RAMONA MUNICIPAL WATER DISTRICT

SUBJECT: 255468:CHENNING: TENTATIVE ADDENDUM NO. 1 TO ORDER NO. R9-2009-0005: AN ADDENDUM TO INCORPORATE REQUIREMENTS FOR THE DISCHARGE OF BRINE AND TO CLARIFY EXISTING REQUIREMENTS.

SAN VICENTE WASTEWATER RECLAMATION FACILITY
BRINE EVAPORATION PONDS
GRADING/IMPROVEMENT PLAN

GRADING/IMPROVEMENT PLAN
 SCALE: 1"=20'

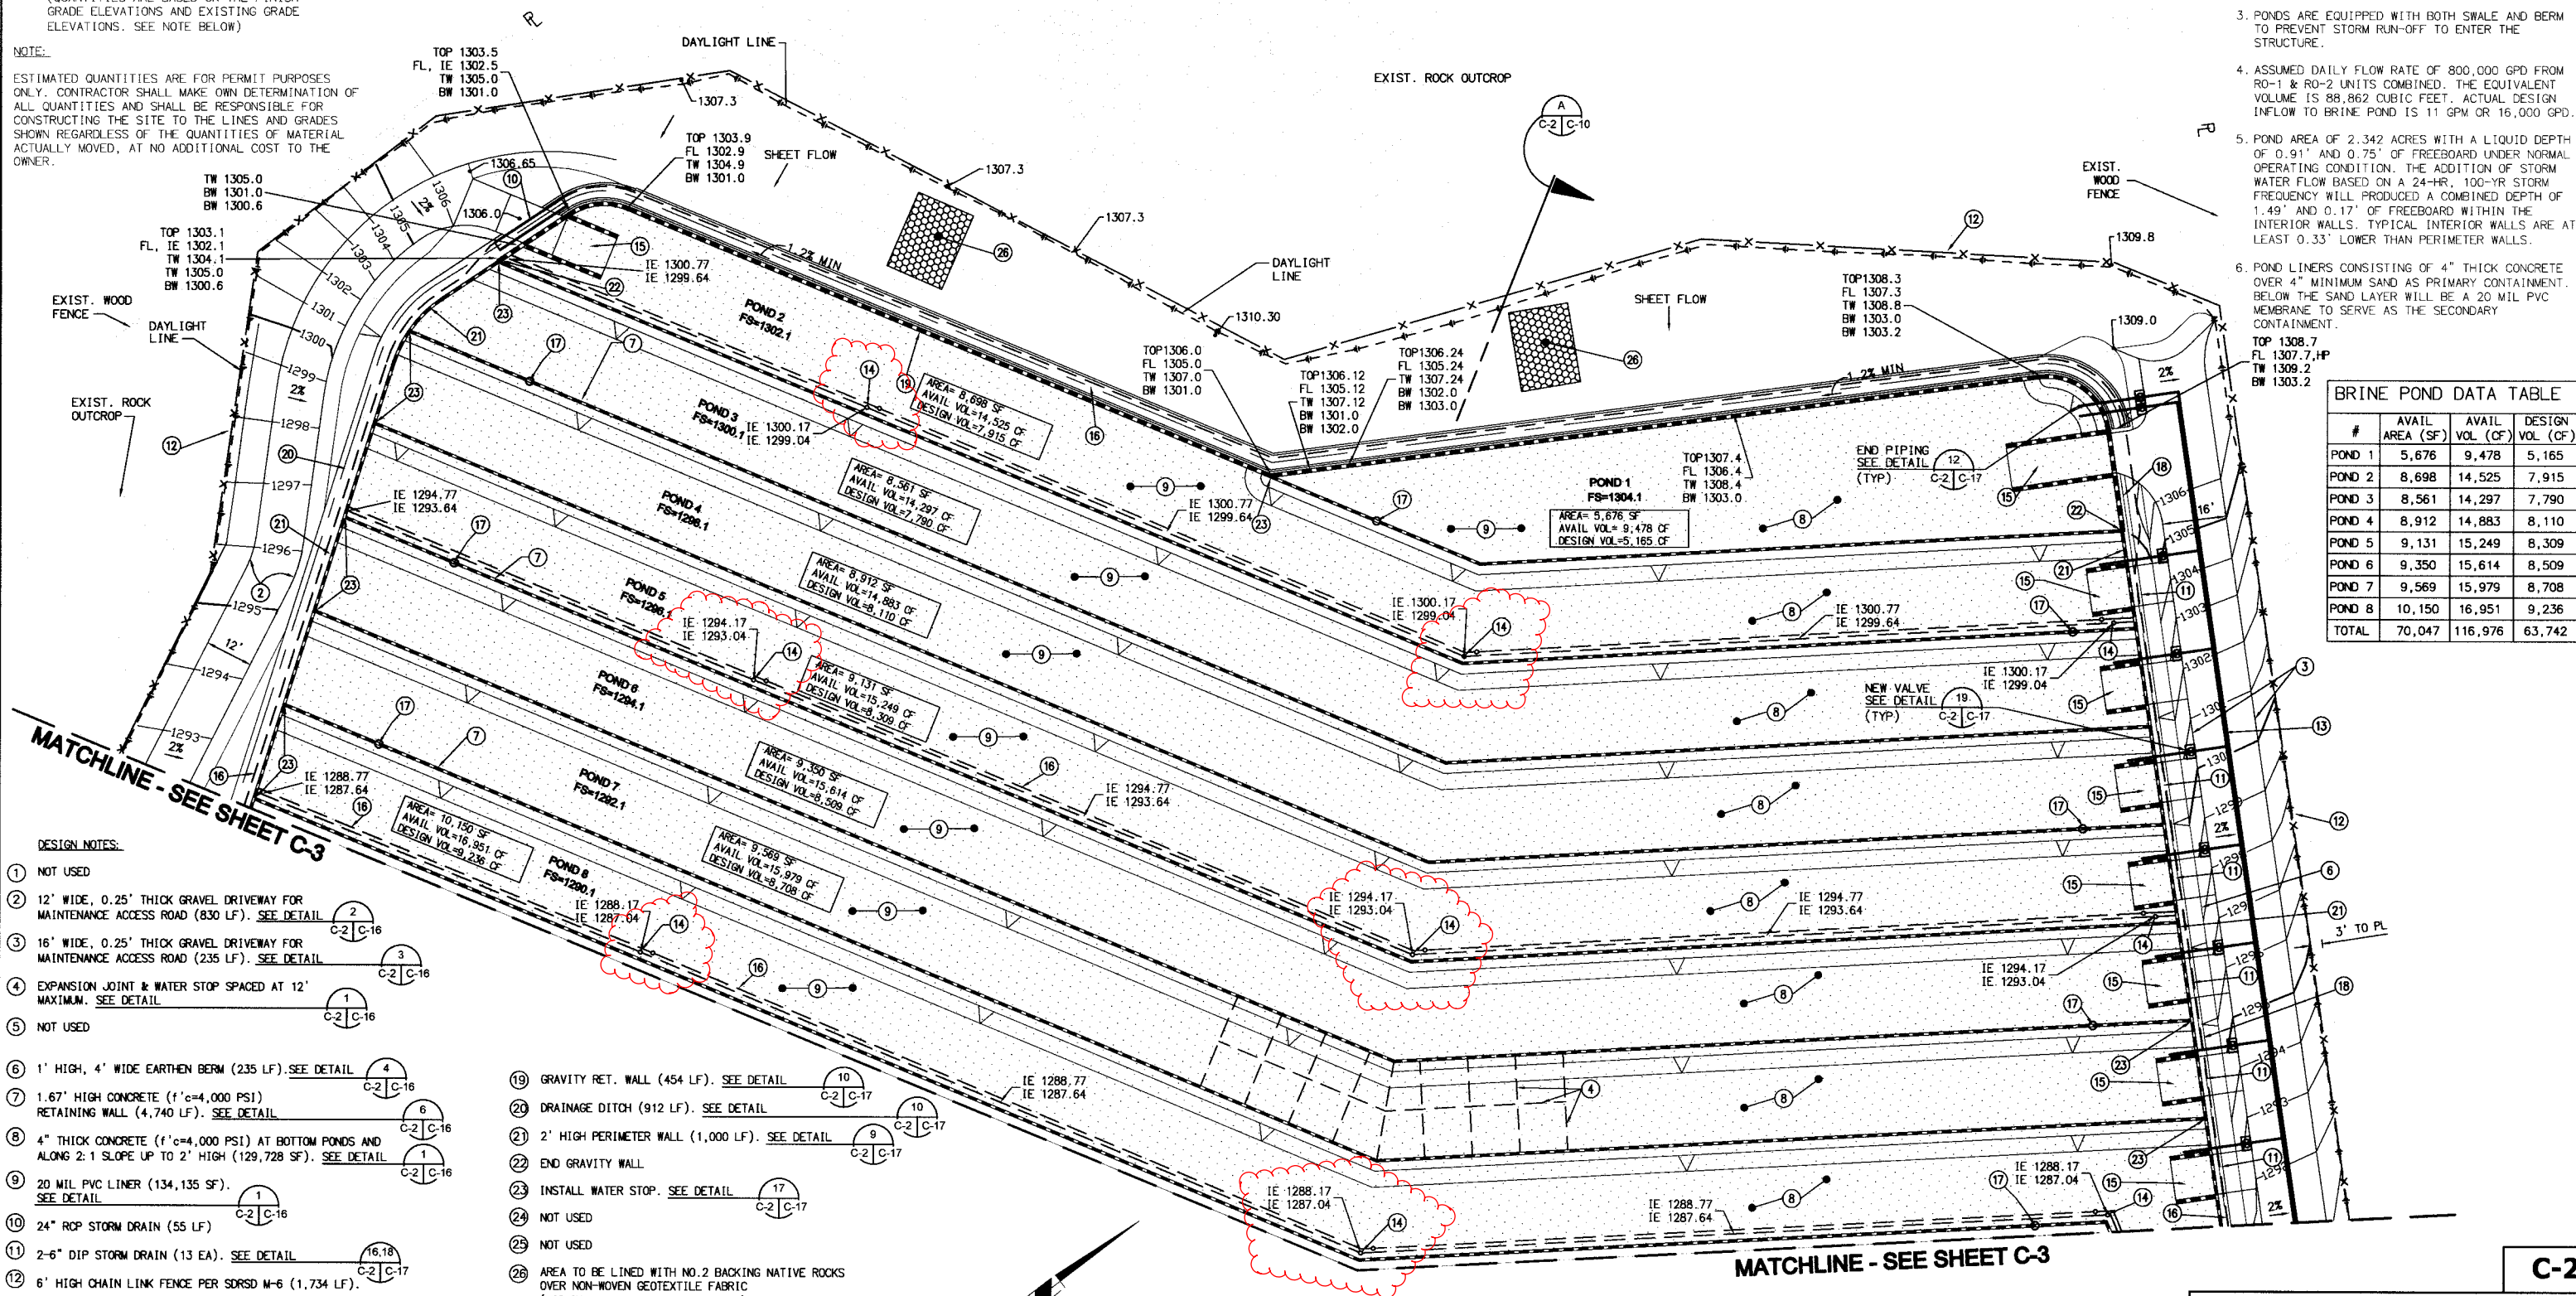
5. On page 9, paragraph 1, a, 3, states that a map of all monitoring points needs to be included in quarterly reports. Our assumption is that this is a map of the observation ports on the leachate collection system, but could be interpreted as being the locations of existing monitoring wells. It is also our understanding that additional monitoring wells will not be required due to the dual containment and collection system constructed with the brine ponds. Attached is a half sized plan of the proposed observation ports on the brine pond.
